Alim Knit (BD) Ltd (Extension)

24 December 2023

Structural Inspection Report

Observation-11: Vehicle impact on slab & parapet wall. (Fire Control & Guard Room)

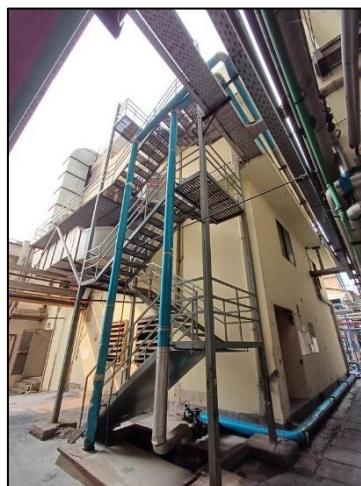
Description: Parapet walls are susceptible to vehicle impact. The building engineer is required to take necessary action to avoid the vehicle impact in the wall.

16.	Vehicle impact on wall. (Fire Control & Guard room)	The building engineer is required to take necessary action to prevent the vehicle impact in the wall.	within 6 weeks

Observation-13: Design report needs to be reviewed for lateral loading. (Generator Building)

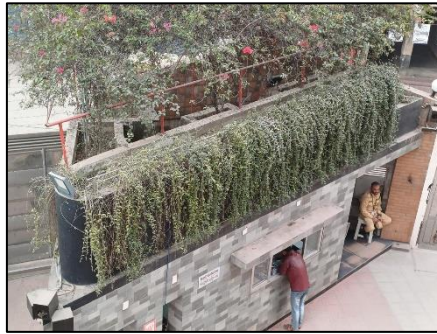
Description: A set of design reports was available for the building. The building engineer is required to submit the design documents of the building and adjacent steel stair to the RSC for detail review against lateral forces.

18.		Carry out suggested remedial works.	within 6 months
19.	Design report needs to be reviewed for lateral loading. (Generator Building)	The building engineer is required to submit the design documents of the building and adjacent steel stair to the RSC for detail review against lateral forces.	within 6 weeks
